COQUILLE INDIAN TRIBE

KILKICH TRANSPORTATION SAFETY PROJECT Response to New Intersection Questions & Concerns September 20, 2023

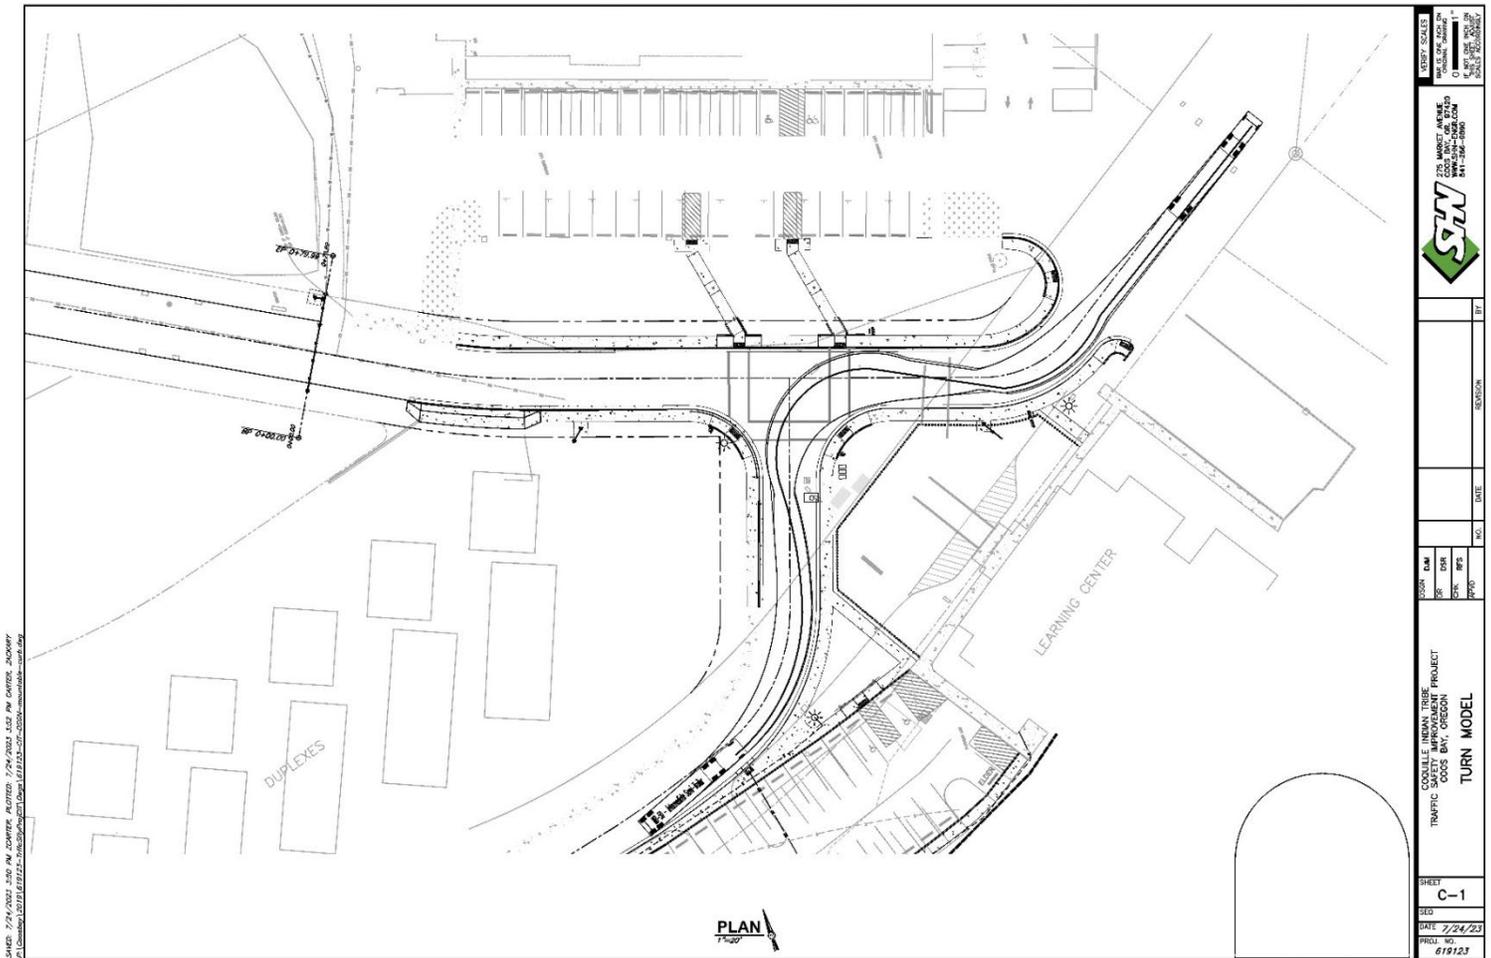
Why is the new intersection so narrow? It seems narrower than standard residential streets, narrower than it was before, and narrower than other spots on Kilkich.

- It does feel narrow with the construction cones and laborers still working in the road.
- Also, the final asphalt for the top of the road hasn't been laid yet, and there are 12 inches on each side of Miluk Drive, at the new intersection, that are raised (the curb/gutter lip), that will be flush and part of the drivable road surface once the project is complete.
- When finished Miluk Drive will be 26 ft wide (see diagram below).

- This is slightly wider than the original width of Miluk Drive (25.5 ft) at the intersection.
